Access Compliance Report

Public Rights-of-Way

(Curb Ramps)

Intersection ID: 10027081	Main Street: GALLERIA_BV	Cross Street: N/A	Location: W
ADA ID: 0D10374EE619	Ramp Type: BlendTrans1	Initial Pass/Fail: Fail	Overall Compliance: No
			Severity Score: 10

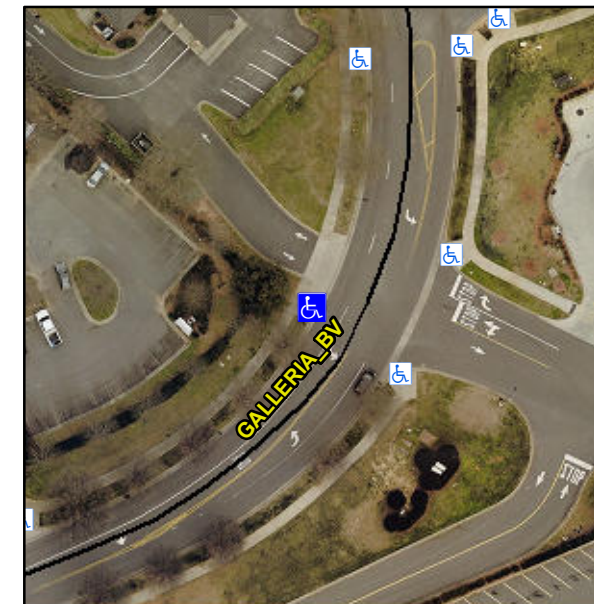
Not Found, R304.5.1

Compliance	Description	Data	Compliance	Description	Data
N/A	Ramp Length (in)	94.0	Yes	BlendTrans Slope (%)	3.1
No	Ramp Width (in)	47.0	Yes	BlendTrans XSlope (%)	2.3
N/A	Flare Type LT	N/A	N/A	Flare Type RT	N/A
N/A	Flare Slope LT (%)	N/A	N/A	Flare Slope RT (%)	N/A
N/A	Flare Traversable LT?	N/A	N/A	Flare Traversable RT?	N/A
N/A	Landing Length (in)	N/A	N/A	DWS Provided?	N/A
N/A	Landing Width (in)	N/A	N/A	DWS Contrast?	N/A
N/A	Landing Slope (%)	N/A	N/A	DWS Length (in)	N/A
N/A	Landing X Slope (%)	N/A	N/A	DWS Full Width?	N/A
N/A	Landing Curb? (Y/N)	N/A	N/A	DWS Offset (in)	N/A
N/A	Shared Landing?	N/A			
N/A	Gutter Ponding?	N/A	N/A	Gutter Slope (%)	N/A
N/A	Gutter Lip Ht (in)	N/A	N/A	Gutter X Slope (%)	N/A
N/A	Painted X Walk1?	No	N/A	Painted X Walk2?	N/A
	X Walk 1 Direction	To SE		X Walk 2 Direction	N/A
	X Walk 1 Width (in)	N/A		X Walk 2 Width (in)	N/A
	X Walk 1 Slope (%)	3.8		X Walk 2 Slope (%)	N/A
	X Walk 1 X Slope (%)	3.2		X Walk 2 X Slope (%)	N/A

N/A	Ramp inside XWalk1?	N/A	N/A	Ramp inside XWalk2?	N/A
	Road Slope (%)	3.2		Clear Space?	N/A
	Road X Slope (%)	3.8	N/A	Clear Space to XWalk (in)	N/A
N/A	Any Obstructions?	N/A	N/A	Storm Grate/Utility Hazard?	N/A
	Obstruction Type			Storm Grate/Utility Type	
		N/A			N/A
			Yes	Surface Condition? (G/P)	Good
			No	Curb Slope (%)	5.8

Remove & Replace Curb Ramp With Two New Directional Ramps or Equivalent.
